**CERTIFICATE OF APPROPRIATENESS**

**Property:** 508 Harvard, Lot 14, Block 289, Houston Heights Neighborhood Subdivision. The property includes a historic 1,821 square foot, one-story single-family residence situated on a 6,600 square foot interior lot.

**Proposal:** Alteration – Porch

HISTORIC DOCUMENTATION

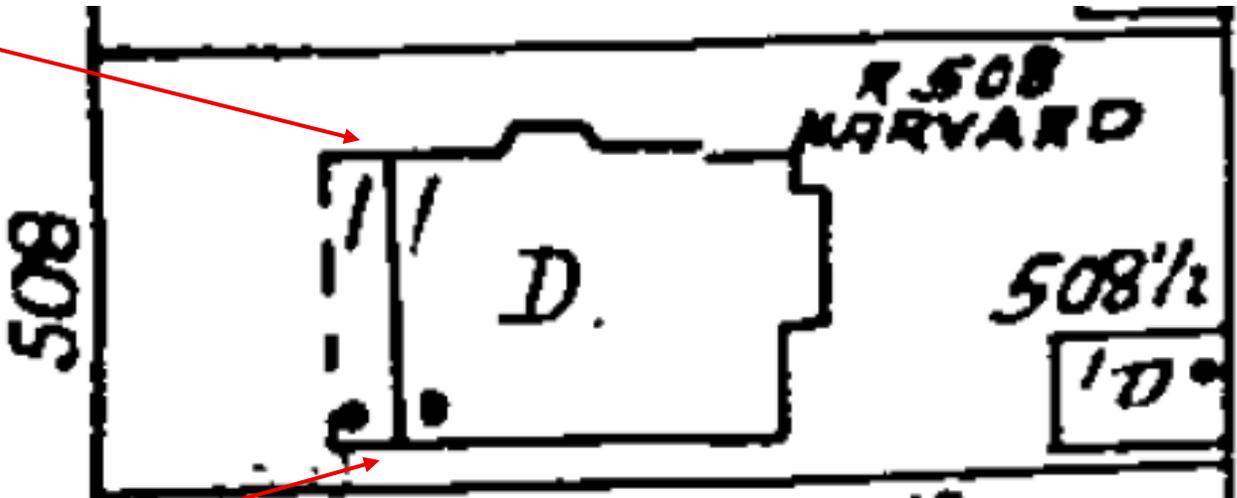
Sanborn shows porch as spanning full width across the front of the dwelling from corner to corner. The existing porch does not go all the way to the corners, suggesting the current design is not original. See BLA on p.6 for more info.

\*NOTE\* Sanborn shows porch as spanning full width across the front of the dwelling from corner to corner. The existing porch does not go all the way to the corners, as it is depicted on the 1968 BLA. This suggests the current porch is not part of the original design intent of the house.
